Alberhill System Project

ENERGY DIVISION STAFF REPORT

November 4, 2021

The purpose of this Energy Division Staff Report is to detail the review and analyses the California Public Utilities Commission Energy Division has conducted to date related to Southern California Edison's supplemental information filed in response to CPUC Decision 18-08-026.

Figure 2: Differences in Independent Capital Analysis BCA and SCE's PVRR Analysis BCA

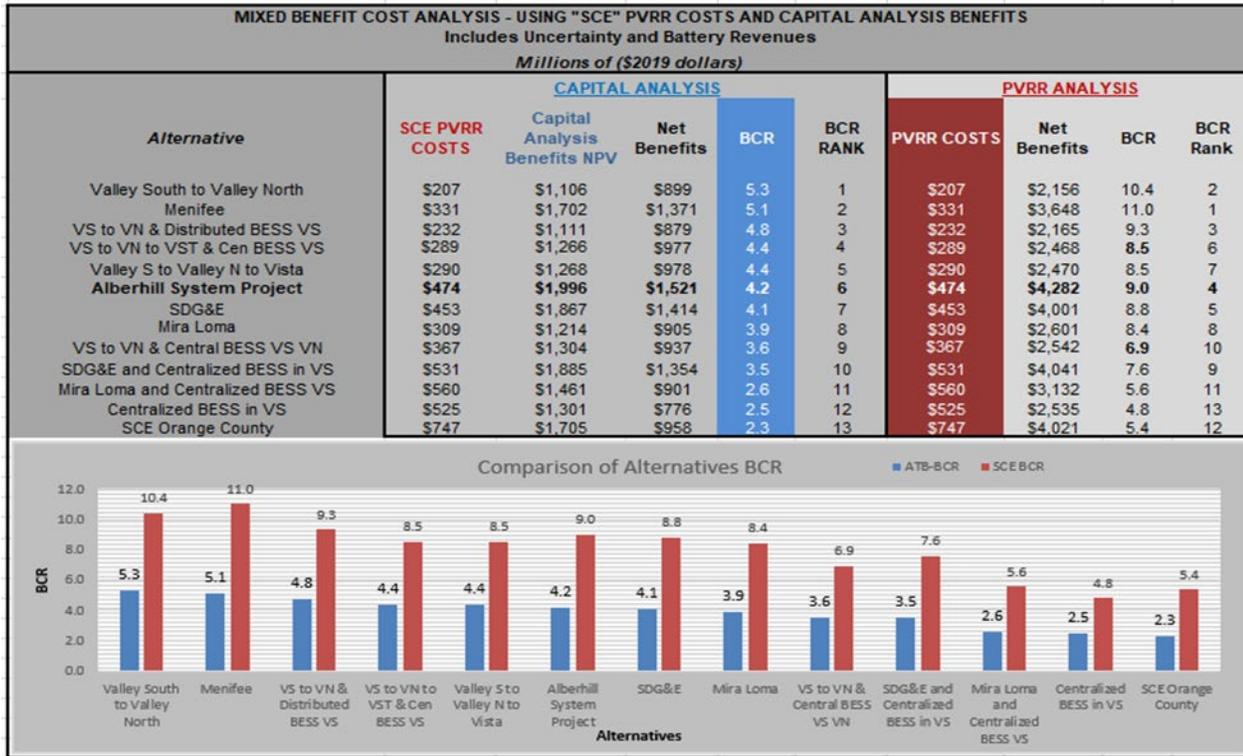
Based on the retiming of benefits beginning to accrue on the appropriate Project in-service date, the most attractive alternatives (in terms of the BCR) were Valley South to Valley North (ranked in first place), Menifee (second place), and Valley South to Valley North and Distributed BESS in Valley South (third place). The proposed Alberhill Project was ranked in sixth place.

SCE documentation emphasizes that the proposed Alberhill Project supplies the best solution in meeting the energy needs of the future, based on its reliability performance. This is paramount to the proposed Alberhill Project’s attractiveness and ultimately displaced all other alternatives as the preferred alternative. Although the reliability of energy capacity needs may justify the proposed Alberhill Project as the best solution, it is also a very costly solution, at \$474 million. In comparison, Valley South to Valley North (first place in terms of WSP’s BCA ranking) costs are only \$207 million; however, it is unclear how this and other alternative systems would perform giving equal consideration to their cost effectiveness, reliability performance, and capacity over time.

Figure 4: Alberhill System Project special protection scheme

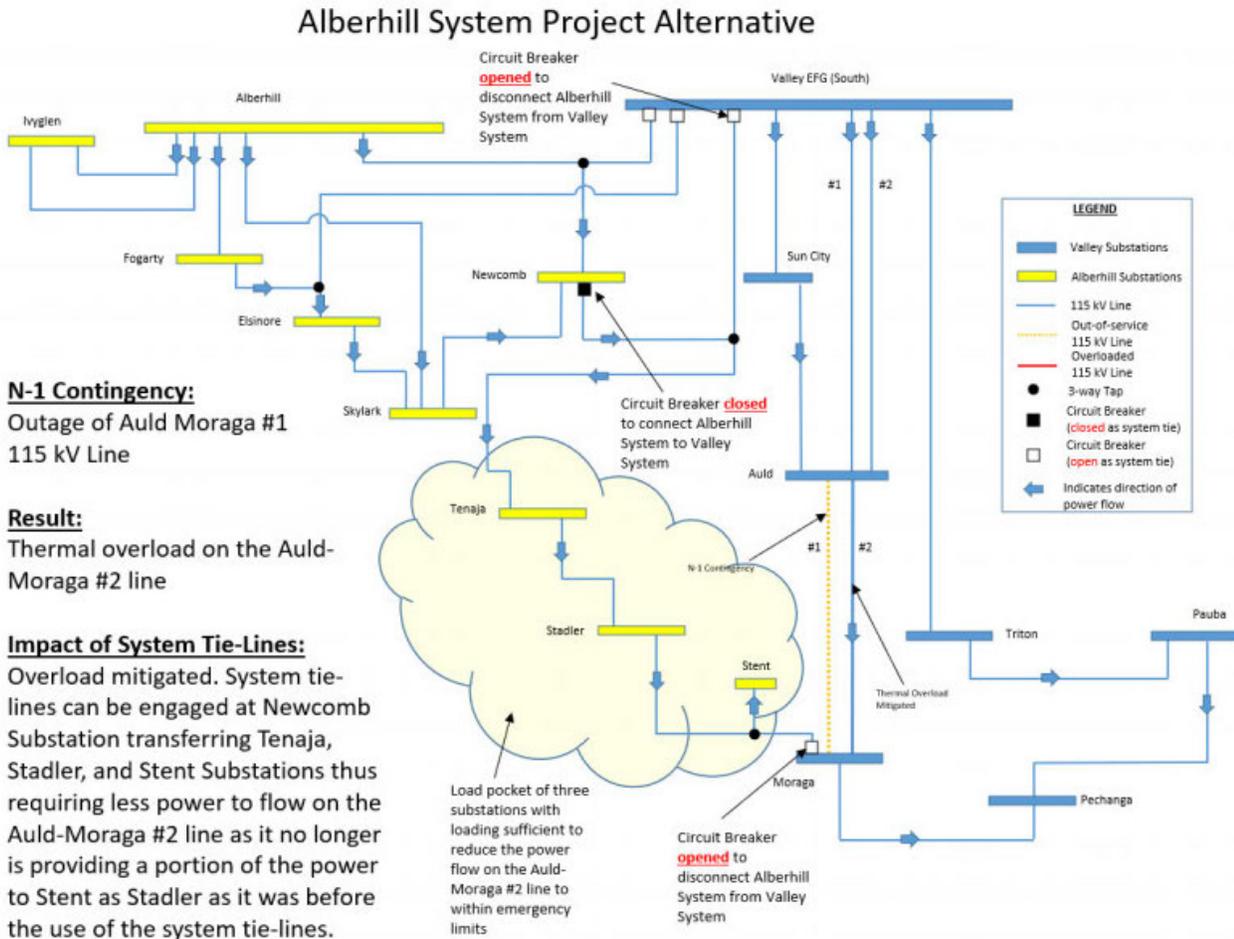
The illustration in Figure 4 below, appears to show a special protection scheme (SPS) in use to alleviate the Auld-Moraga 115 kV #2 line overload. Without the deployment of this SPS, it would appear that the ASP does not relieve this overload. Kevala’s power flow analyses showed that when one Auld-Moraga 115 kv line is out of service, the remaining Auld-Moraga 115 kV line experiences an overload. This result was consistent for all alternatives and ASP. Therefore, it appears that without the use of a SPS, the tie-lines in the Valley South to Valley North alternative are as effective as those in the ASP.

Figure 2. BCA 1: BCA Capital Analysis Compared to SCE BCA PVRR Analysis (includes Uncertainty and Battery Revenues)

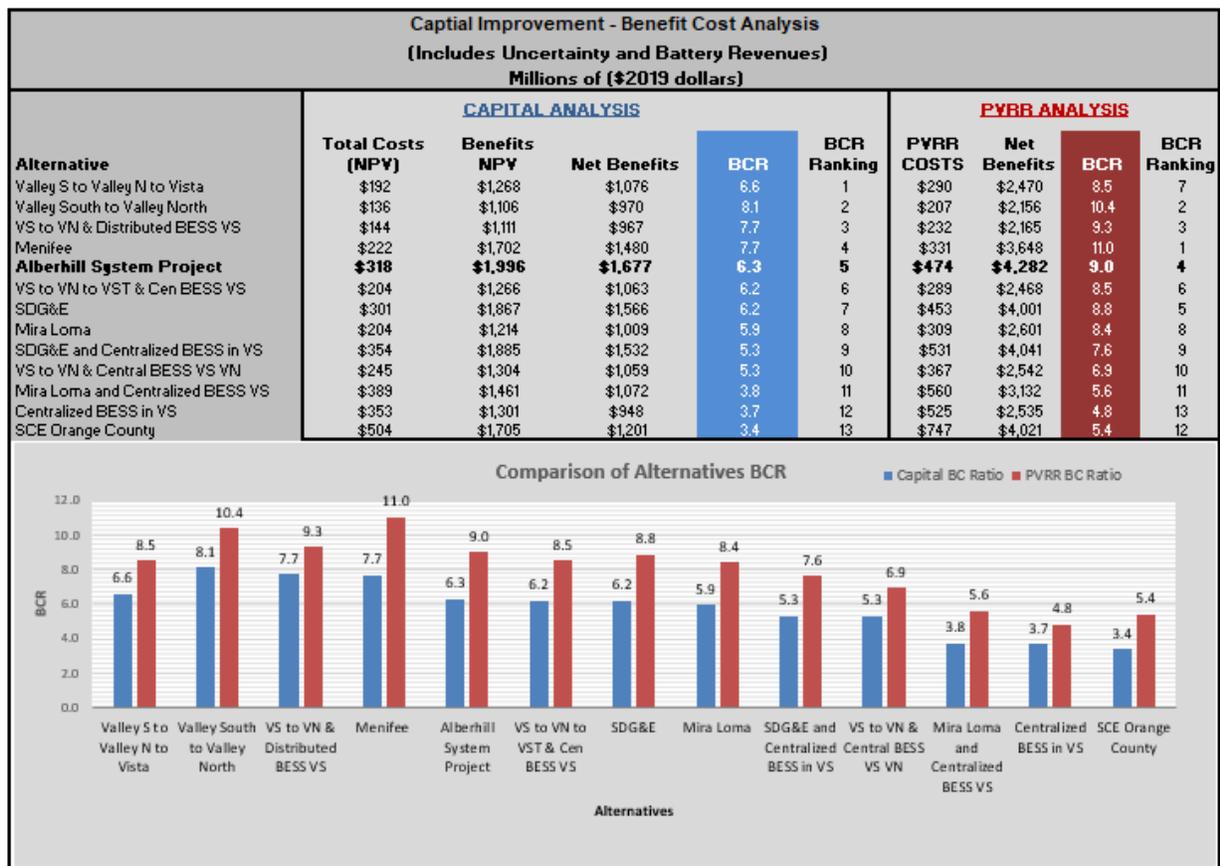
BCA1, a time series analysis, is a traditional capital improvement benefit cost analysis. It does not use SCE’s PVRR computations, rather it uses the estimated stream of undiscounted capital costs, O&M costs, and benefits (as provided in SCE’s spreadsheets), all timed correctly, over the project life span, including both uncertainty and battery revenues, then discounted these expenditures equitably using a 10 percent discount to a common point in time (the base year). This analysis resulted in the following BCR rankings. SCE BCRs and net benefits are consistently higher than the capital analysis (of BCA1) among all alternatives, which brings up the question *was the PVRR figure appropriately discounted?* In any event, conducting the capital analysis using the 10 percent discount rate reveals that the Alberhill System Project (Alberhill) is similarly ranked fifth with a BCR of 6.3; however, with the SCE analysis, Alberhill was ranked fourth with a BCR of 9.0. In terms of net benefits, BCA1 model shows a net benefits reduction from \$4.3 million to \$1.7 million, but Alberhill remains first in both evaluations.²

Figure 3. BCA 2: BCA Capital Analysis Compared to SCE BCA PVRR Analysis (excludes Uncertainty and Battery Revenues)

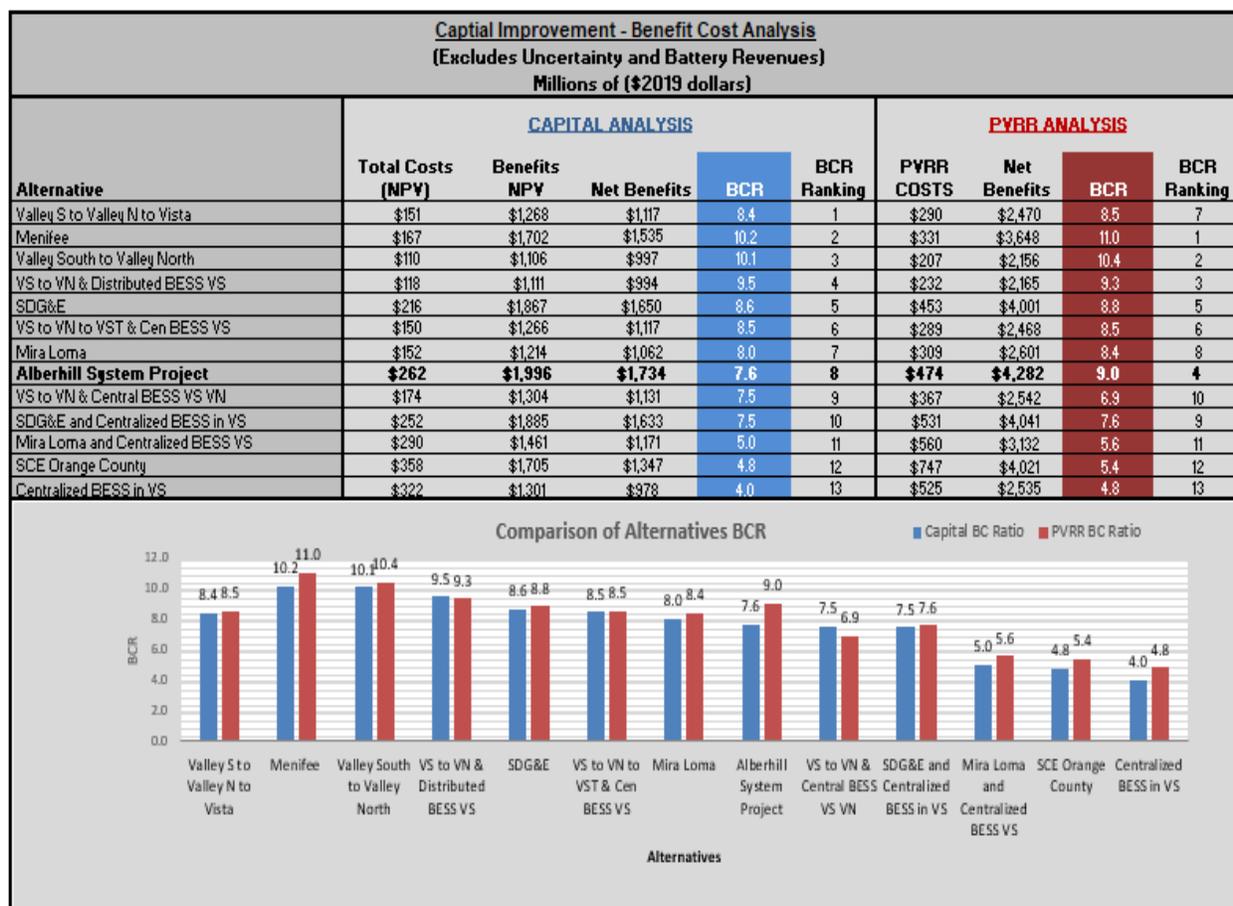
BCA2 is similar to BCA1 but excludes uncertainty and battery revenues from the costs streams, while all other time series factors remain the same. Although excluding uncertainty and battery revenues from the capital analysis has closed the BCR gap (between the capital and PVRR analyses), net benefits still are considerably divergent. This can be explained in part from the fact that the SCE benefits were not appropriately treated (discounted) in the year the projects become operational. The reason for the divergence in the costs is unknown. In any event, Alberhill moves to eighth in the BCR ranking compared to fourth with SCE evaluation. In terms of net benefits, as shown in Figure 3, several alternatives show similarly sized net benefits (in the range of \$1.7 million to \$1.9 million) when compared with Alberhill.

Figure 4. BCA 3: BCA Capital Analysis Compared to SCE BCA PVRR Analysis (includes Uncertainty and Battery Revenues)

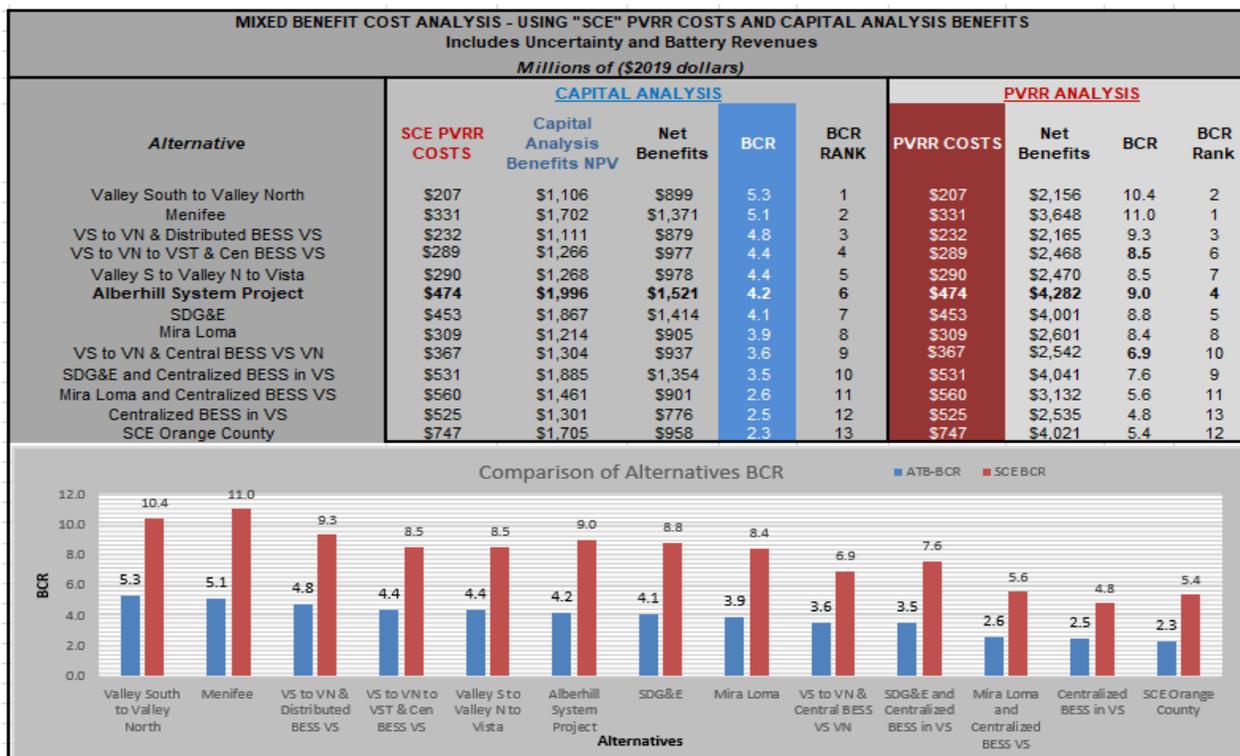
Similar to BCA1, BCA3 is a hybrid capital improvement benefit cost analysis. Unlike BCA1, BCA3 uses SCE’s PVRR computed costs and coupled with SCE’s benefits timed correctly (including battery revenues and uncertainty). Under BCA3, Alberhill places sixth in the BCR ranking, and in terms of net benefits, as shown in Figure 4, several alternatives show similarly sized net benefits (in the range of \$1.7 million to \$1.9 million) when compared to Alberhill.

In terms of the Alberhill System Project, BCA1 (using a 10% discount rate) has a total project cost of \$318 million (net present value) while BCA3 (using SCE’s PVRR computed costs) has a much larger total project cost of \$474 million (net present value). While BCA1 and BCA2 use different methods for computing total project costs, both BCA1 and BCA2 include uncertainty and battery revenues, times the accrual of benefits based on their actual occurrence (in-service, operational date), and all other factors are held constant.
